ADDENDUM #2

Rye City School District

Osborn Elementary School

Midland Elementary School

ONE HOUR RATED PARTITION

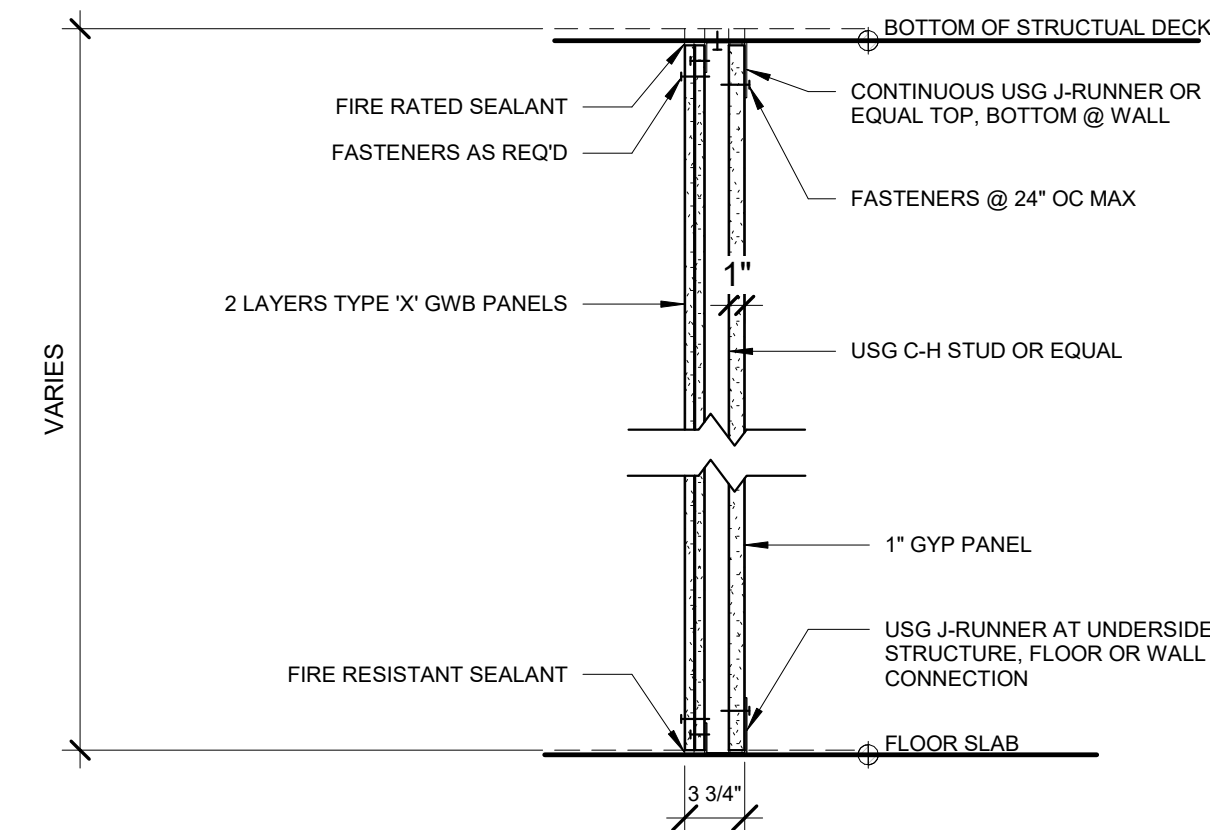
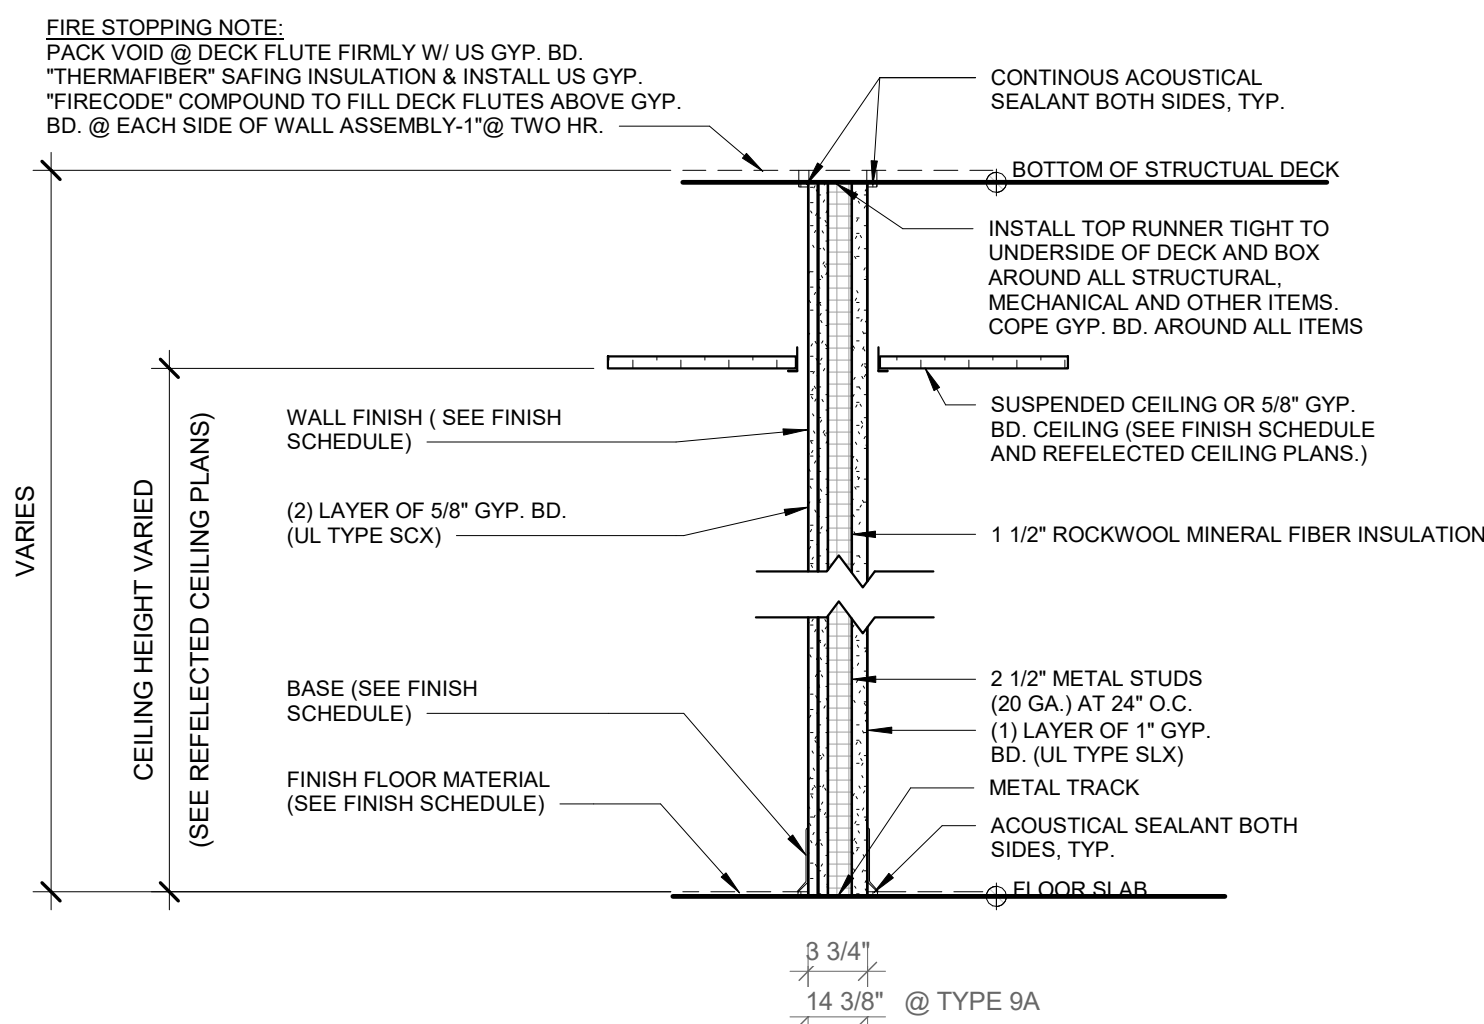
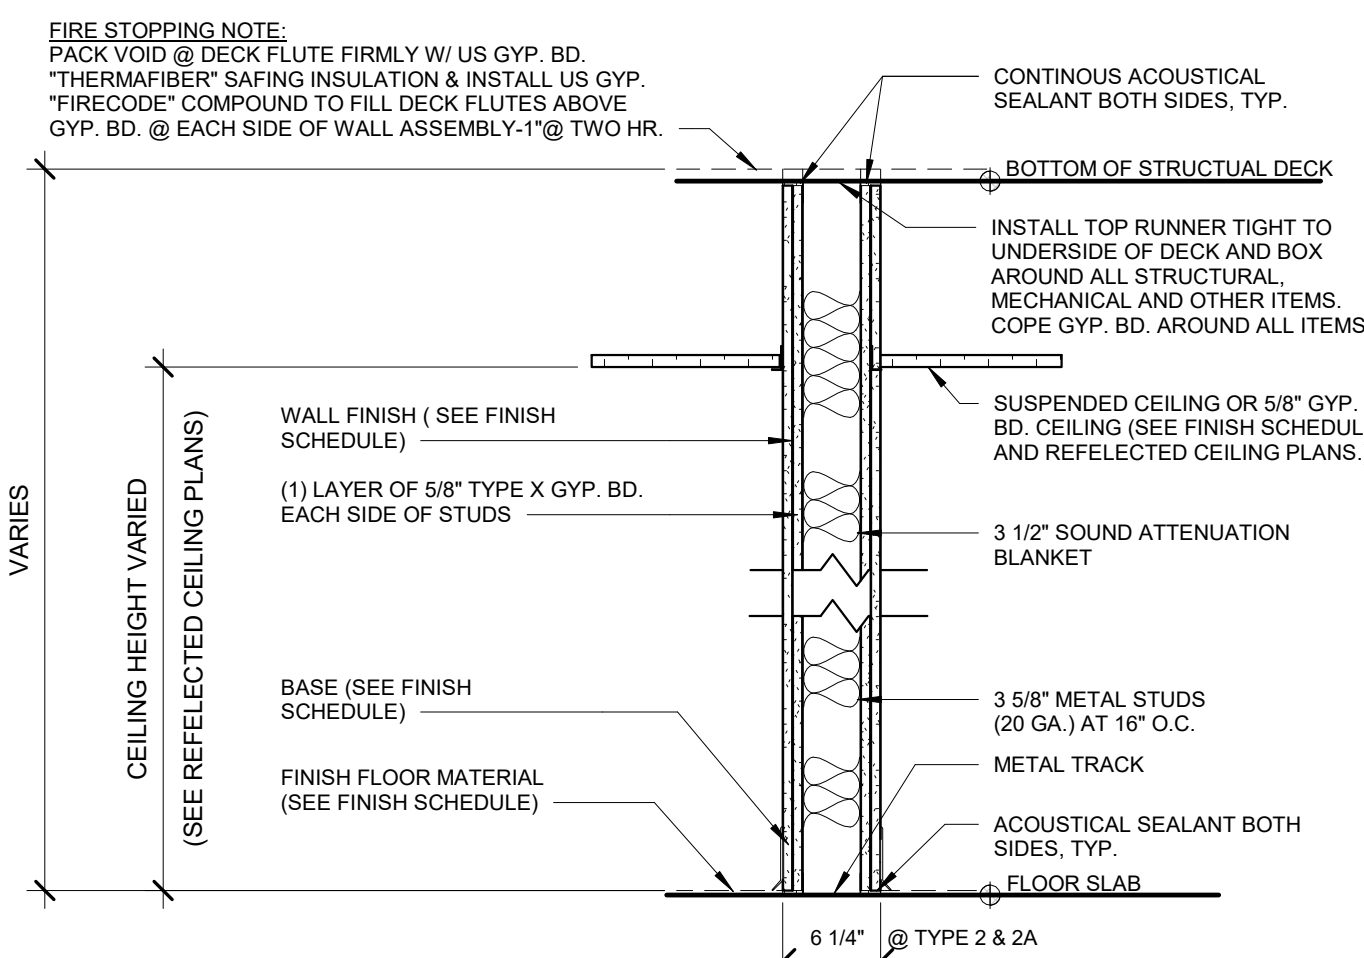
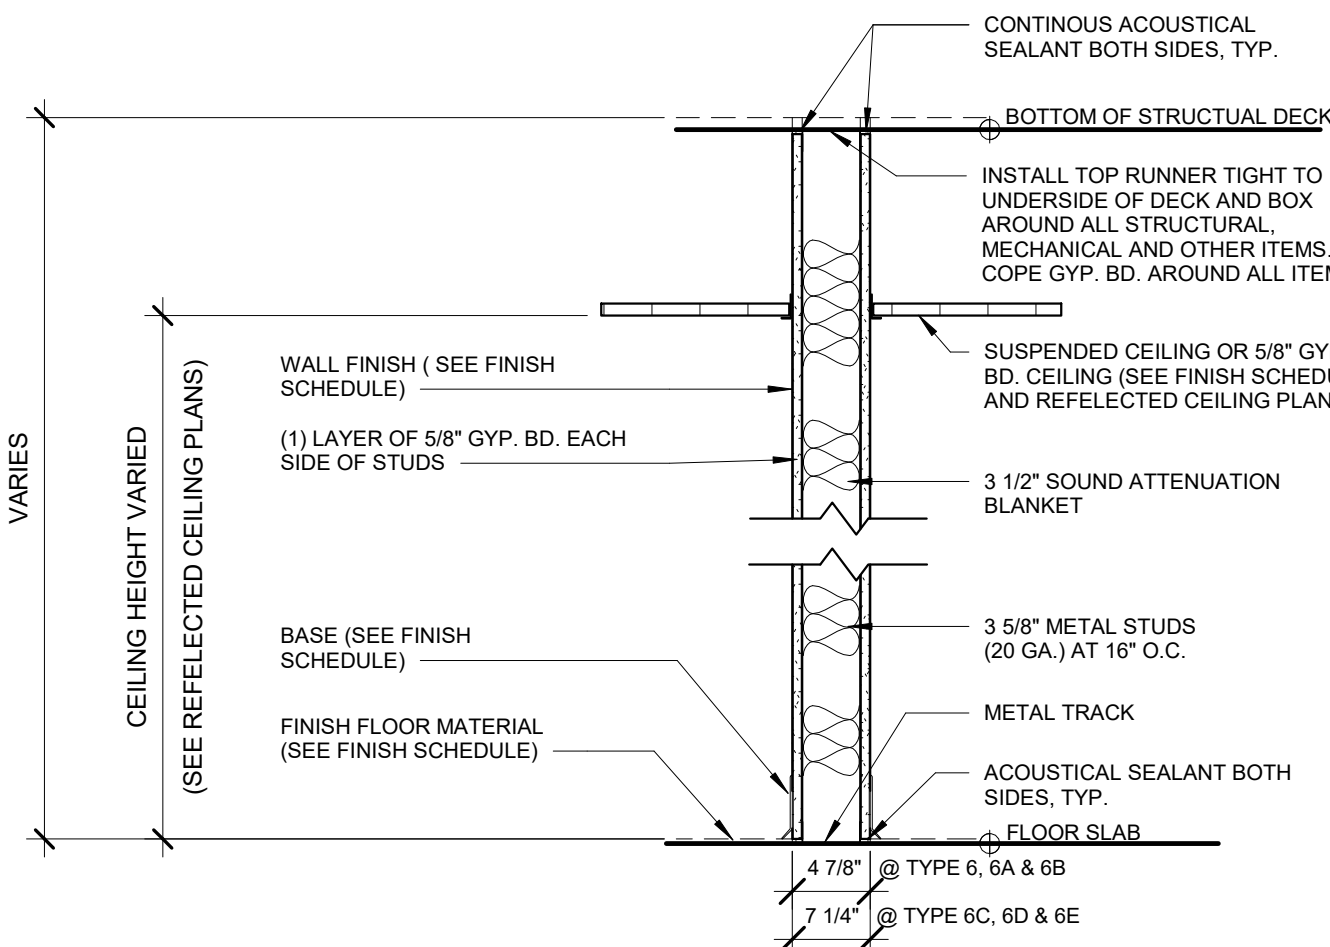
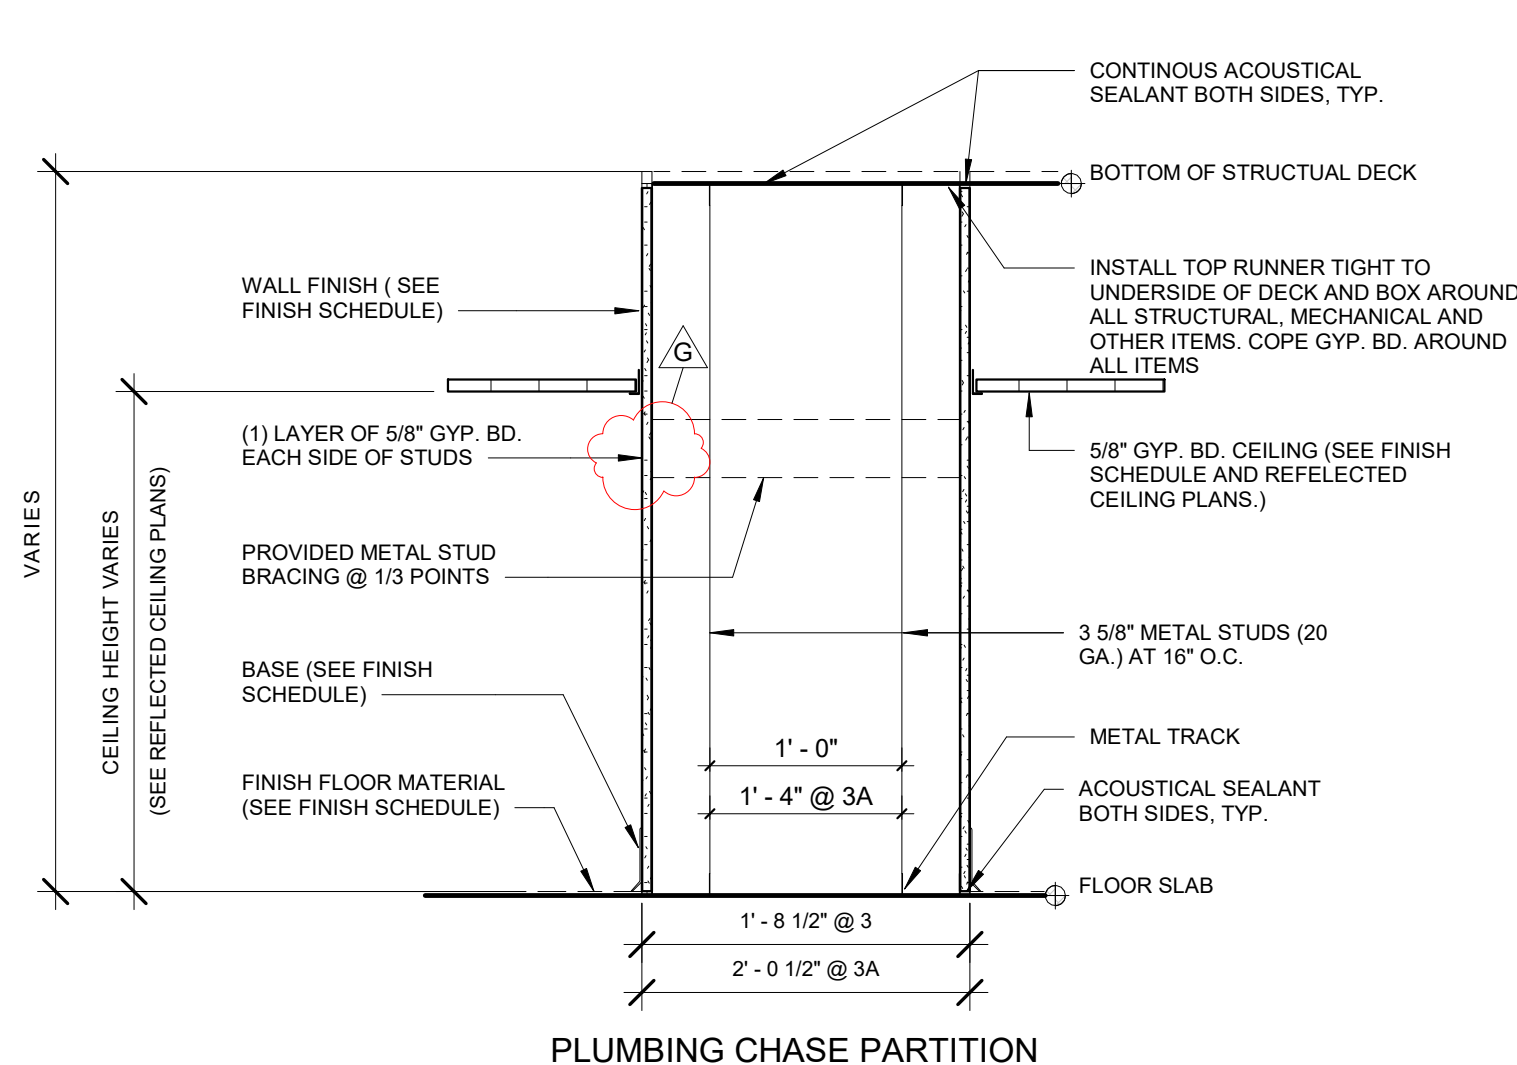
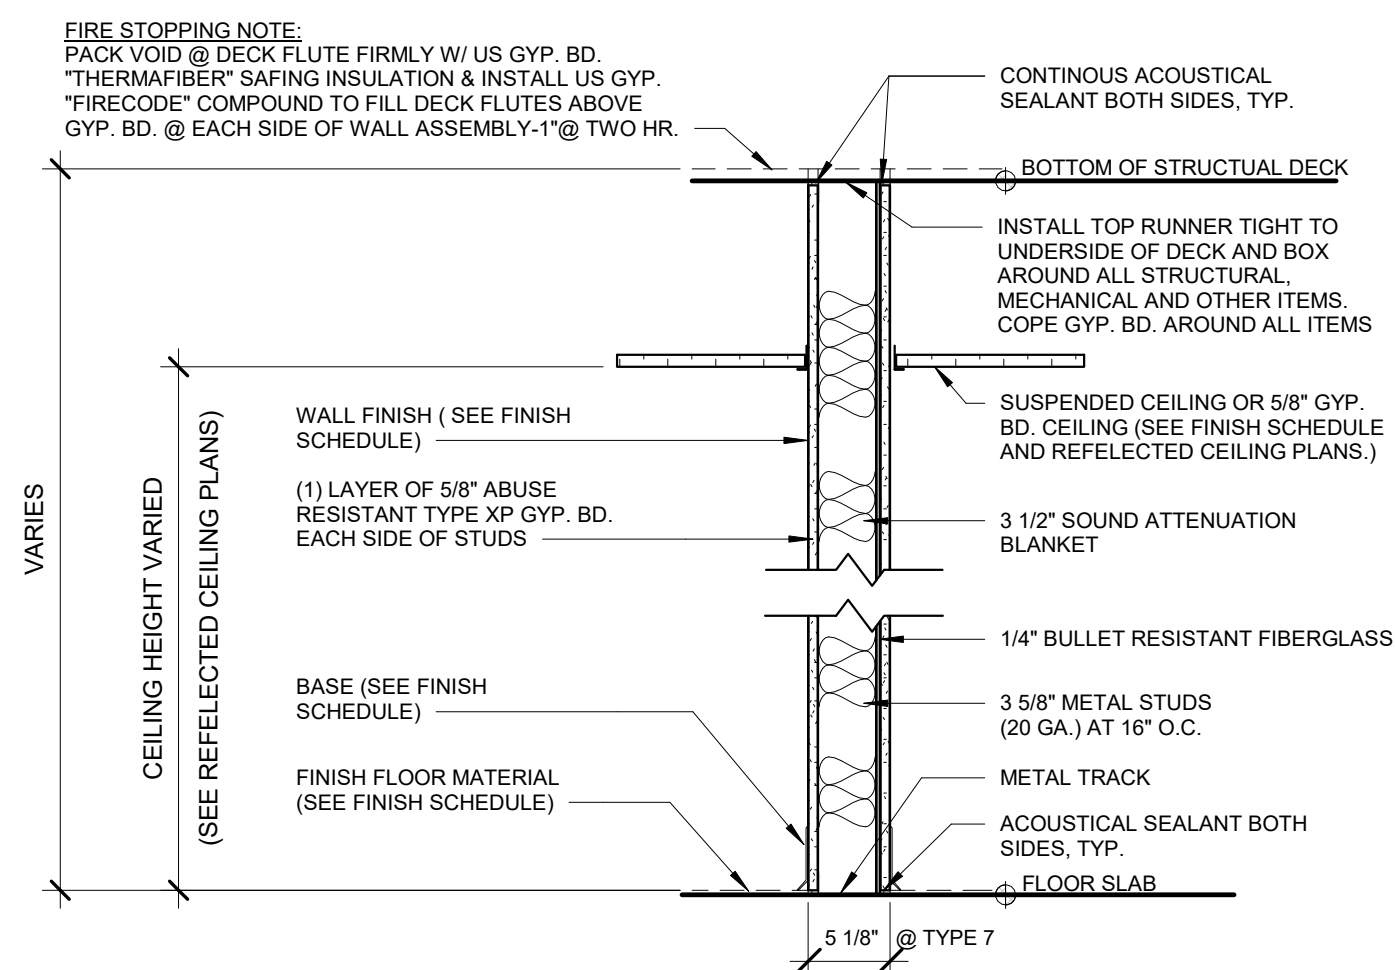
- a. Wall type 3D added
